FREEDOM OF INFORMATION COVERSHEET

FOI reference: TCCSFOI 2018-016

**Certificate of Design Acceptance for [REDACTED] Yarralumla
(Two Units Development)**

GENERAL ARRANGEMENT PLAN

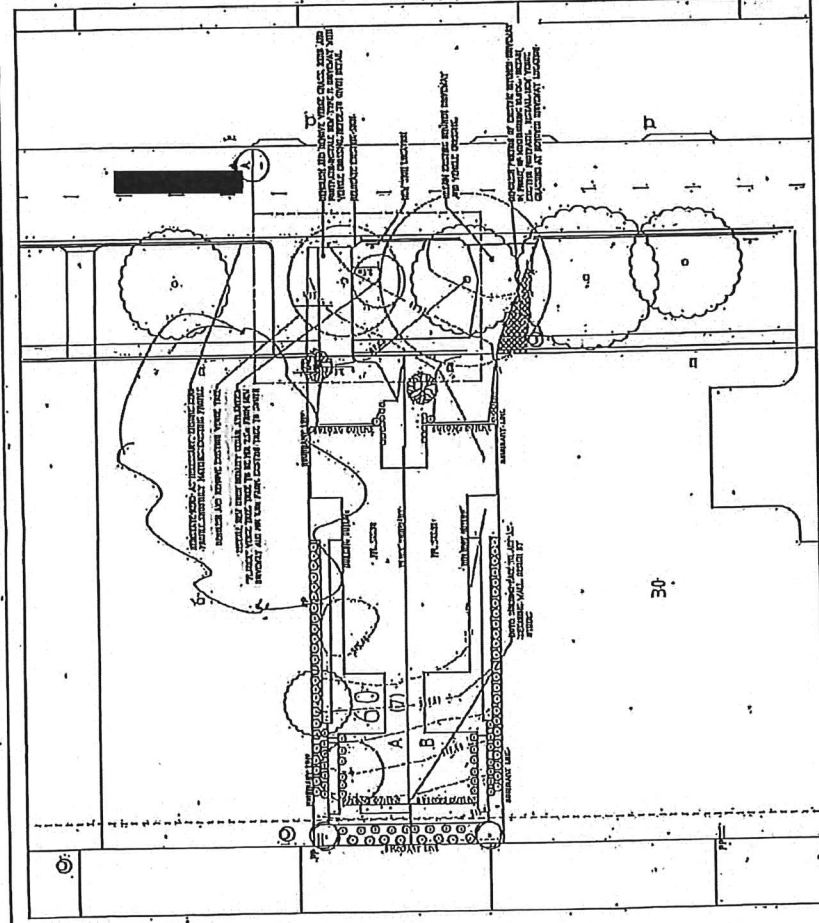
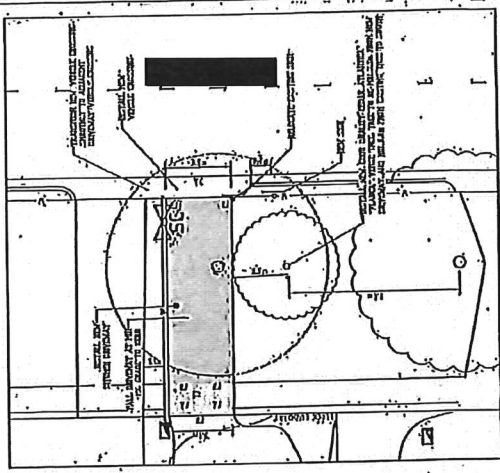
Consultant proposes to remove a tree in order to install the Driveway and also install a new tree "Cedar Atlantica Flauca 2.5 m offset from Driveway (I have highlighted as cloud). Please comment on the proposal and species of the tree.

The General Arrangement Plan for [REDACTED] Yarralumla (151226 C301 Issue D) is consistent with the conditions outlined on behalf of Urban Treescapes when approval to remove the northern cedar was provided late last year. As such we support the location of the new driveway and the location of the replacement street tree.

Please note that the new *Cedrus atlantica* 'Glauca' is to be selected from advanced, good quality tree stock (2.5m+) and meet Australian Standards 2303: Tree Street Stock for Landscape Use (e.g. single trunked, with good amenity tree form and sufficient calliper to be self-supporting). The new tree is to be maintained for a minimum of 12 months prior to formal handover to TCCS Development Review and Coordination.
